Project Name: Post Oak - HVAC

Project No.: 221125-050

**END OF ADDENDUM NO. [#2]**

POST OAK HVAC  
IMPROVEMENTS  
LANSING SCHOOL DISTRICT  
2020 Post Oak Ln, Lansing, MI 48912

# EP1.1

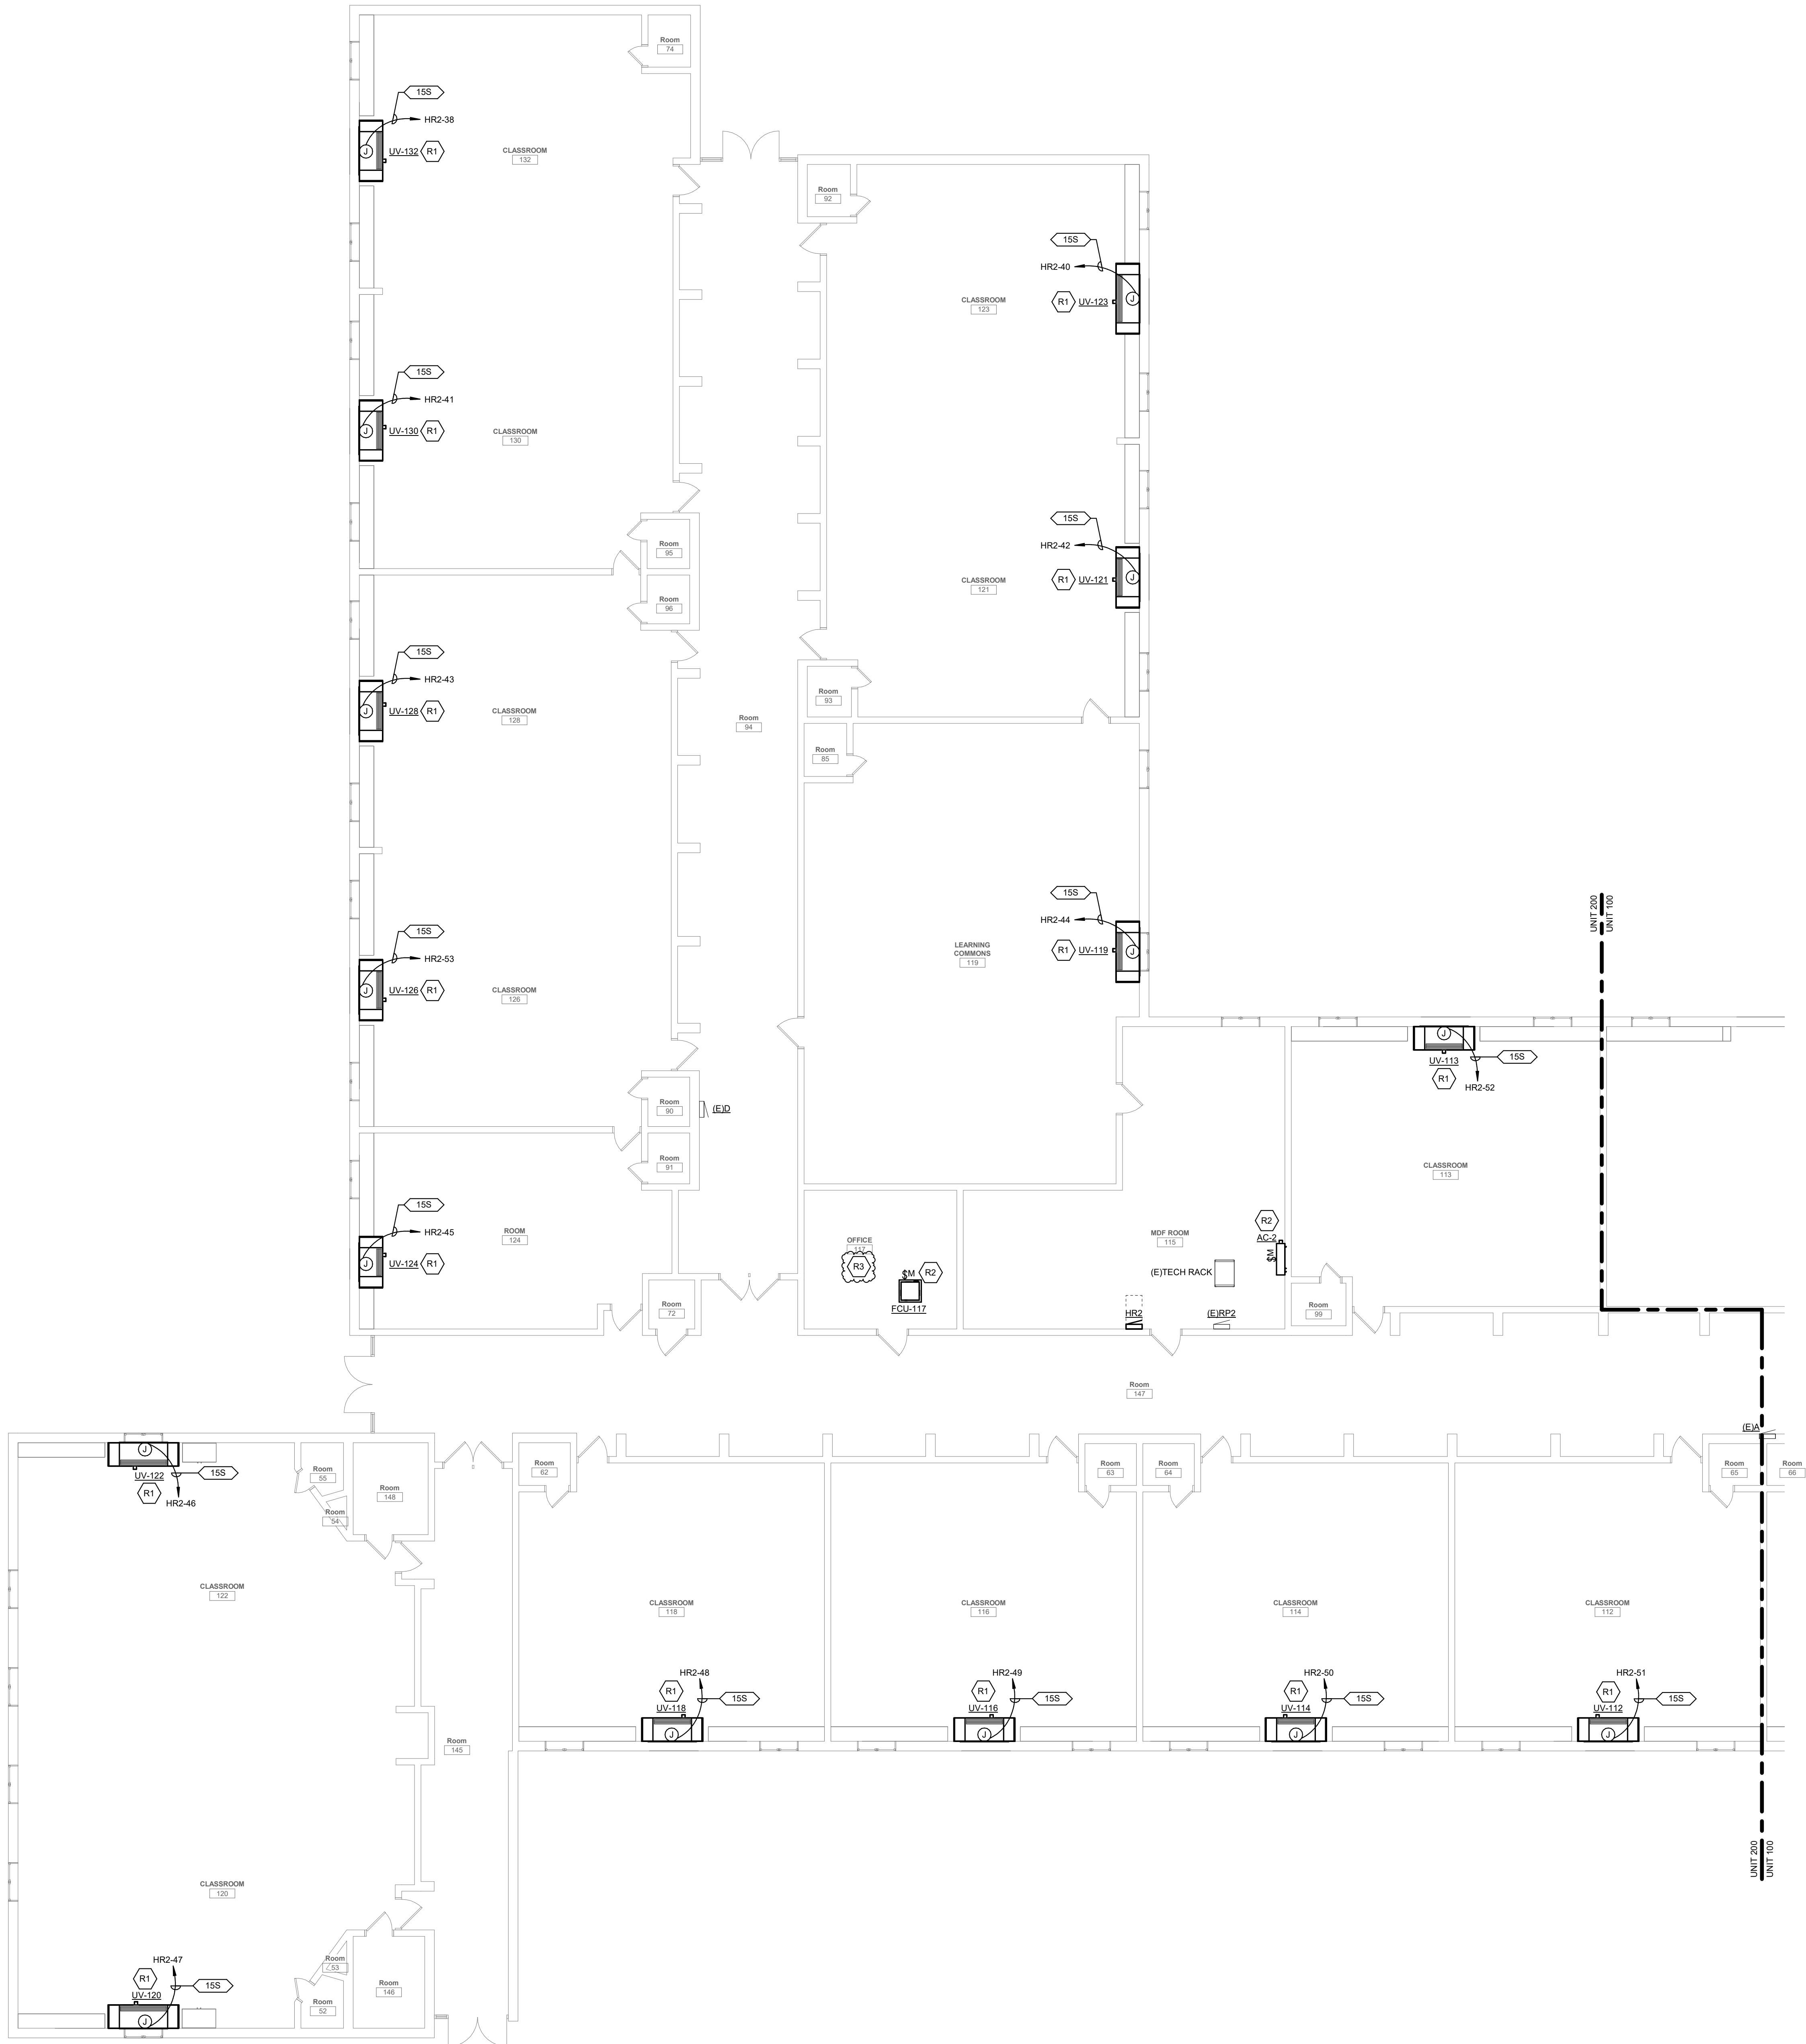
EP1.1: First Floor Power Plan – Unit 100 (Re-issued)

- Revised keynote D2.
- Added keynote R3 to office areas where indicated.

FIRST FLOOR MECHANICAL DEMOLITION PLAN - UNIT 100  
SCALE: 1/8" = 1'-0"

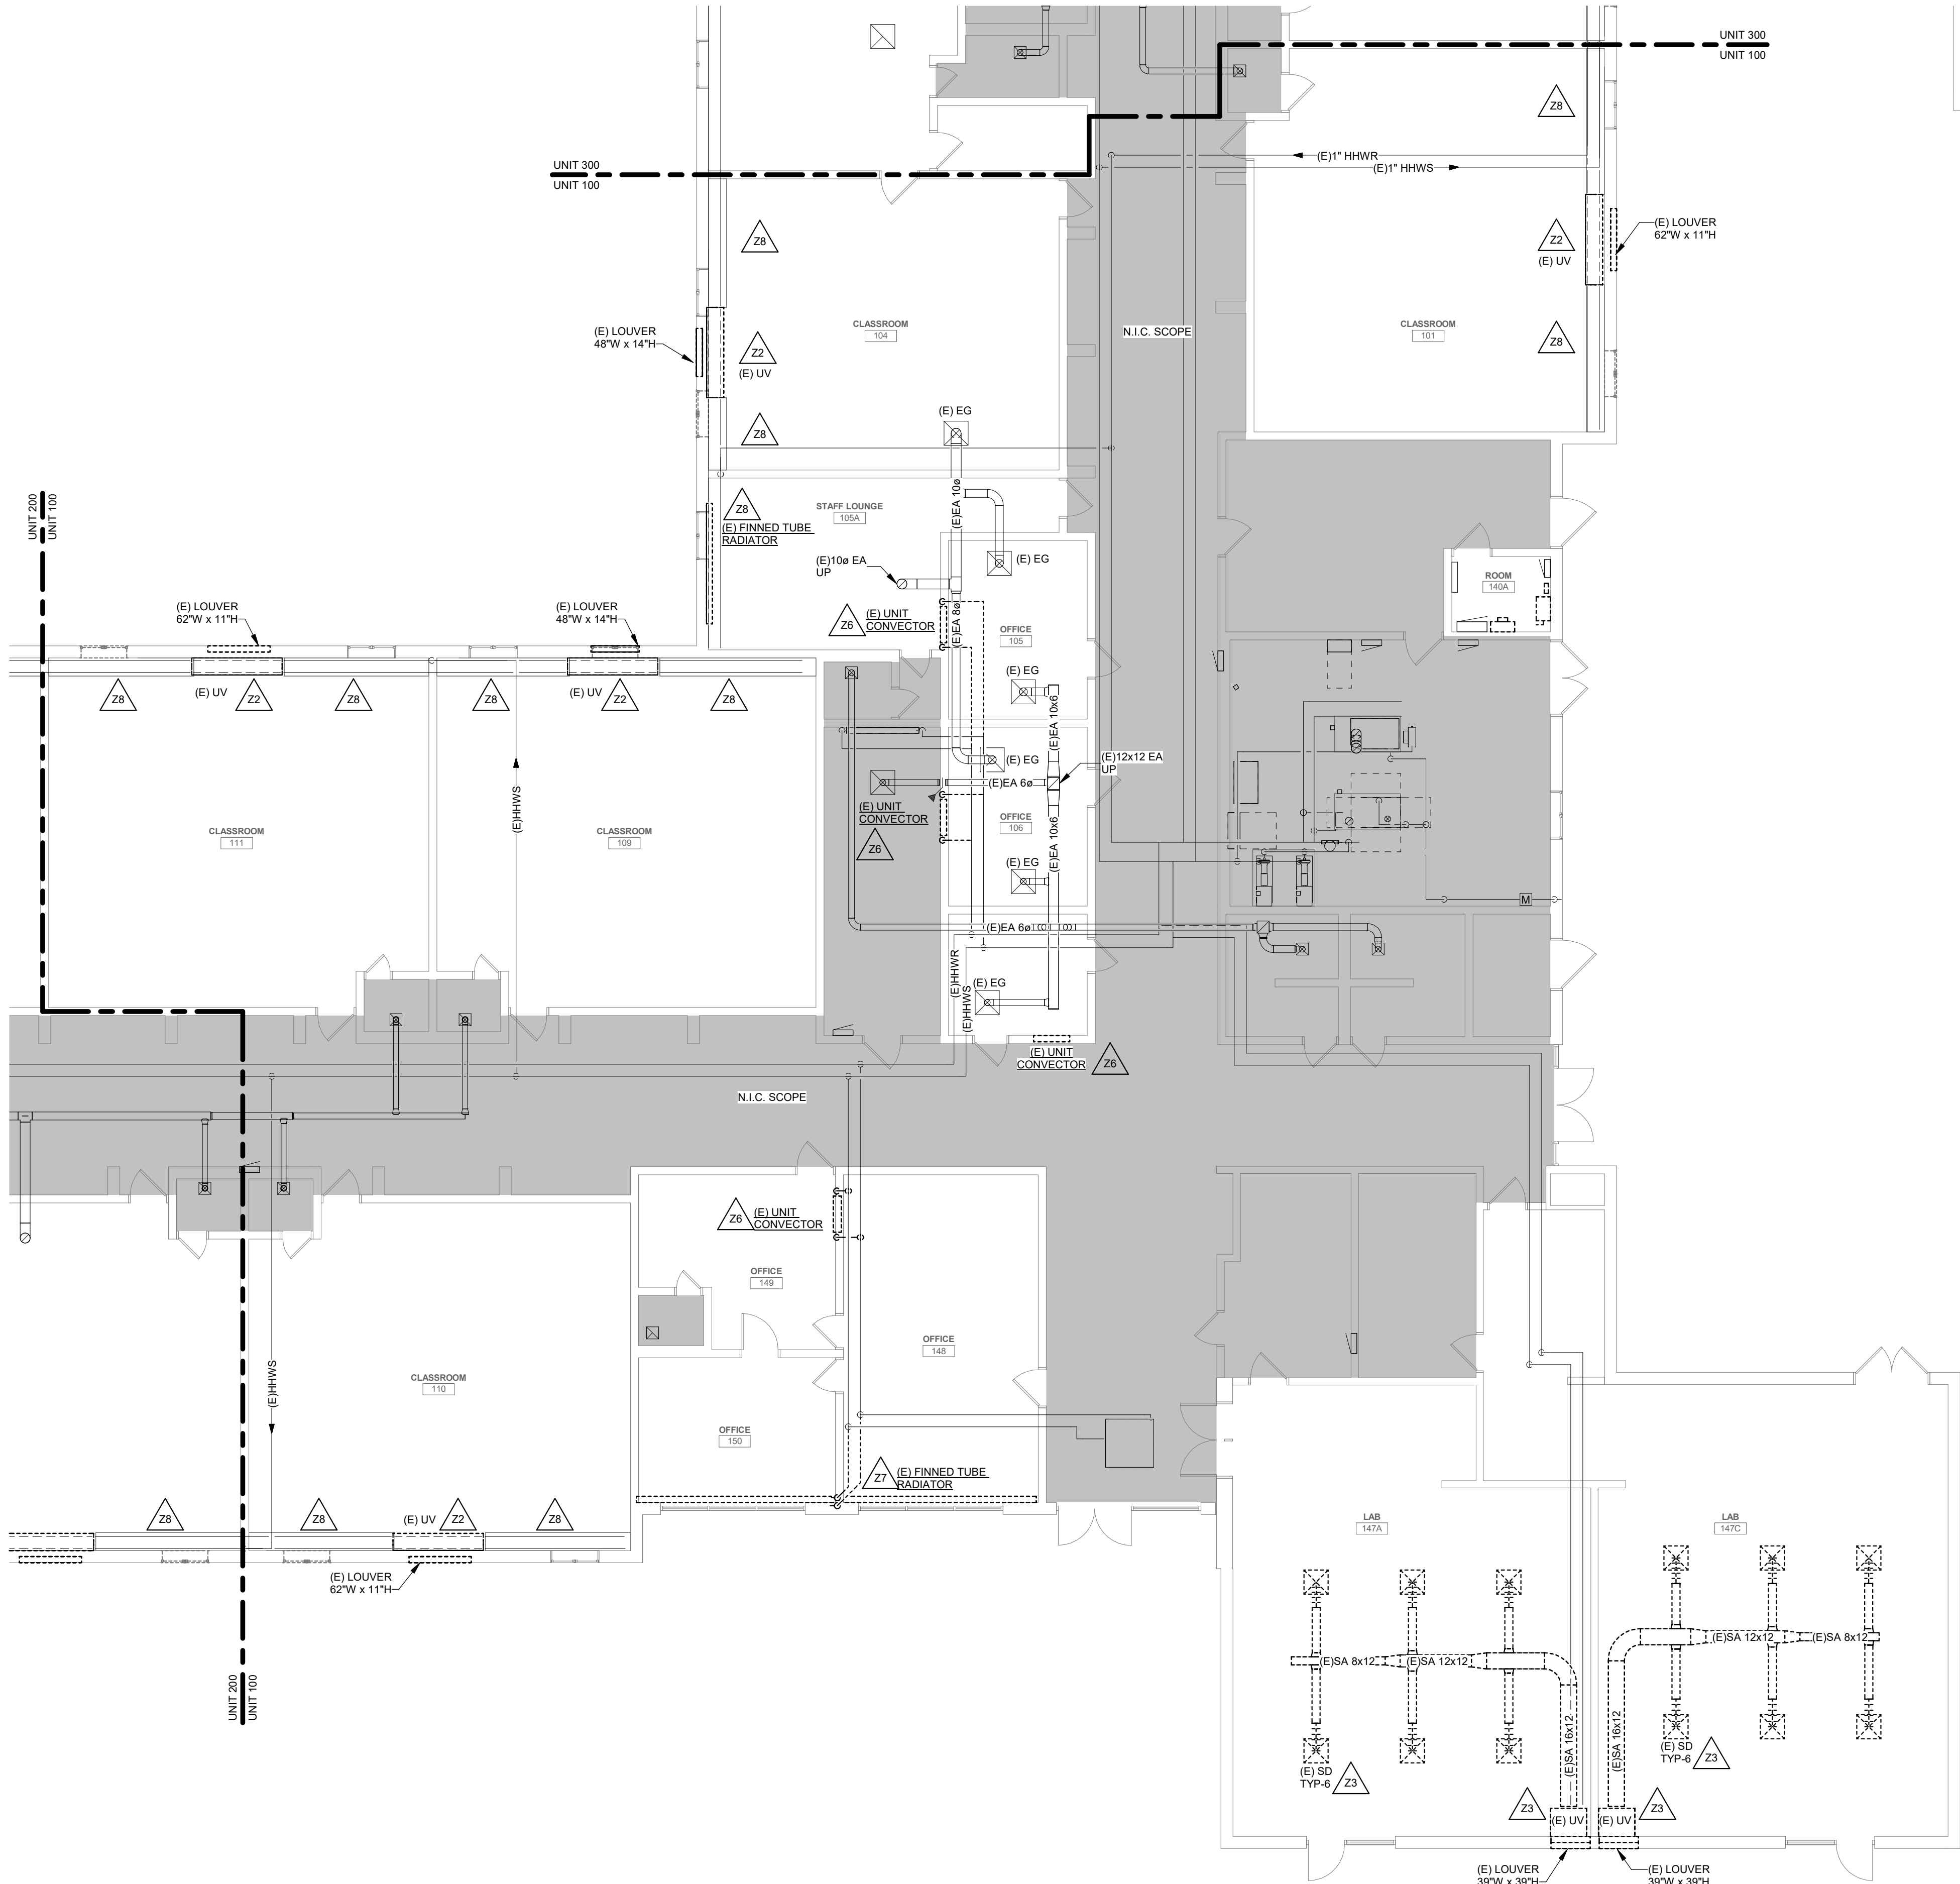
MD1.1: Mechanical Demolition Plan – Unit 100 (Re-issued)

- Revised demolition keynote language.

FIRST FLOOR MECHANICAL HVAC PLAN - UNIT 300  
SCALE: 1/8" = 1'-0"

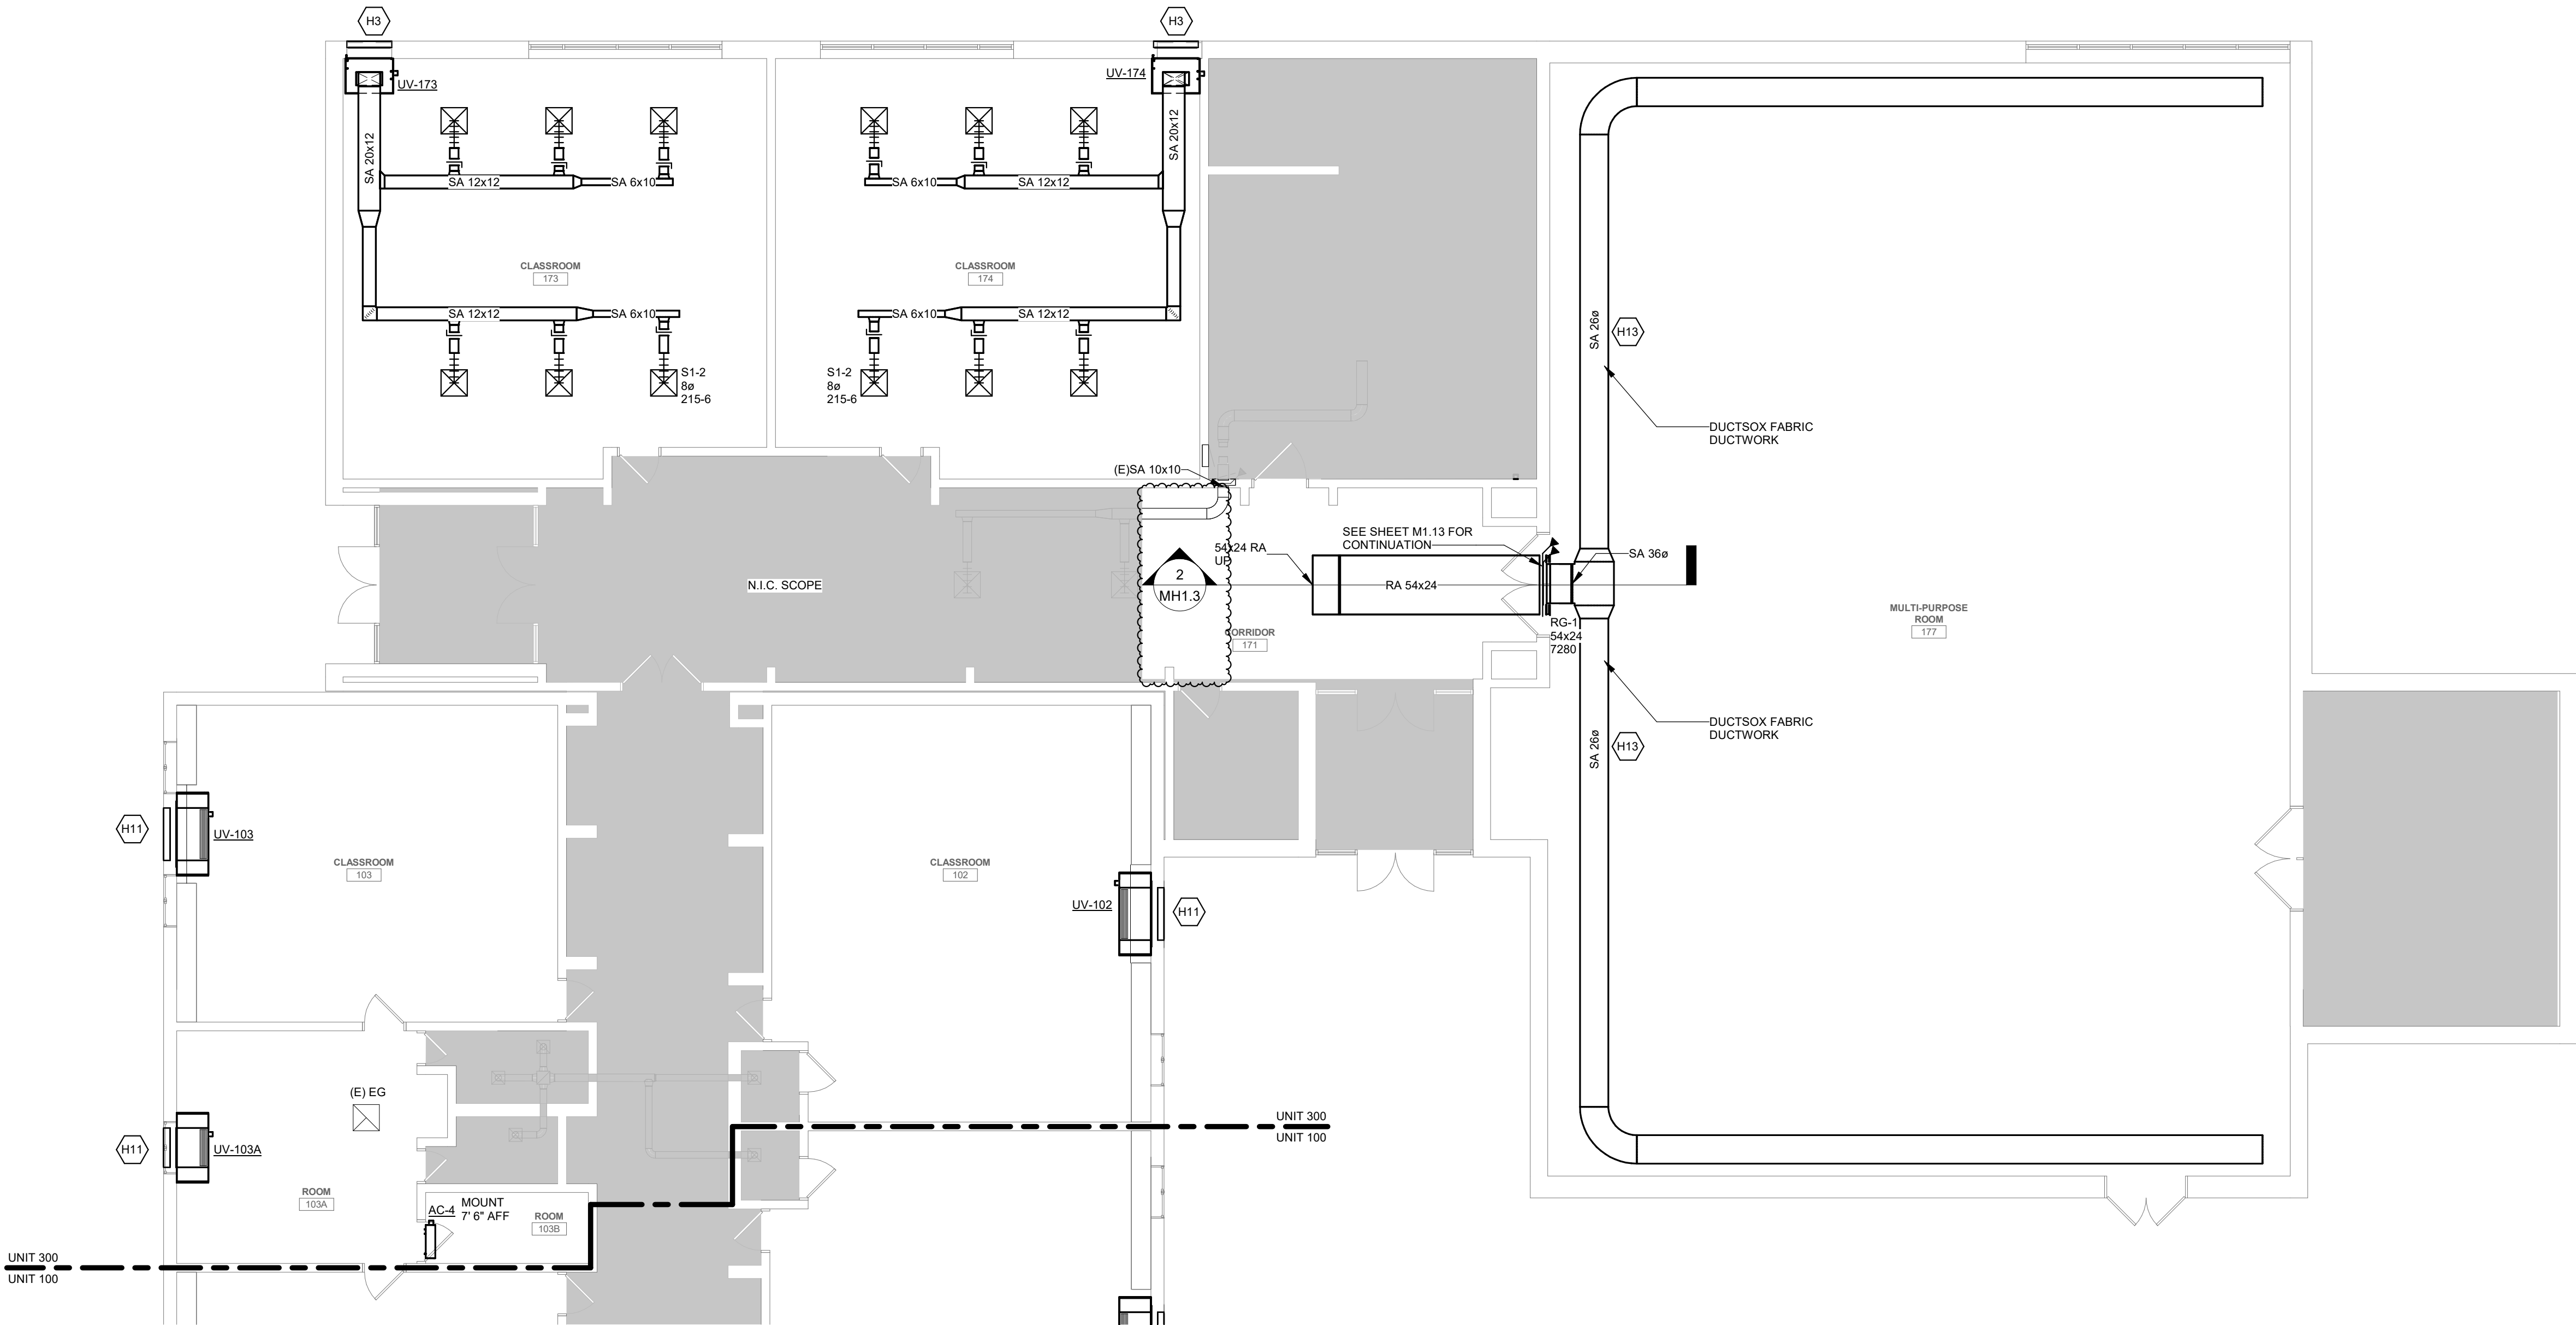
MH1.3: First Floor Mechanical HVAC Plan – Unit 300 (Re-issued)

- Revised N.I.C. scope area to indicate correct scope of work.
